# UNITED STATES PATENT AND TRADEMARK OFFICE

APPLICATION NO.	FILING DATE	FIRST NAMED INVENTOR	ATTORNEY DOCKET NO.	CONFIRMATION NO.
09/822,575	03/30/2001	Naoki Nagasako	09792909-4797	7195

# Office Action Summary

## **DETAILED ACTION**

**FIG.5**

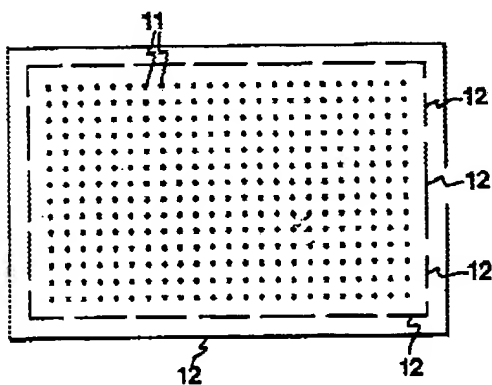
As to claim 1, Lagerwall discloses in Figures 5 and 3A a liquid crystal display apparatus comprising: a liquid crystal panel having a pair of substrates, 1 and 2, facing each other; and liquid crystal material (col. 9, lines 9-12) sealed between said pair of substrates, said pair of substrates being sealed at a first seal portion, 4, which is located at peripheral portion of said substrates and also being sealed at a linear-shaped spacer, 12, (Applicant's second seal portion) located outside of an effective picture element area separated from the peripheral portion and further wherein a supporting height of the first seal portion and the second seal portion is substantially the same, and the seal portions are adhered to the opposite substrate with a binder or any other type of joint (col. 11, lines 23-25 and col. 12, lines 22-25).

Lagerwall teaches dot-shaped spacers, 11, (Applicant's said second seal portion includes said dot-shaped seal portions) at neighbor of corners of said effective picture element area (four corners in figure 5) and further includes linear-shaped spacers, 12, (Applicant's linear-shaped second seal portions/part(s)) located and extending along an edge of the effective picture element area on all four sides (Applicant's opposite to said injection gate for liquid crystal material).
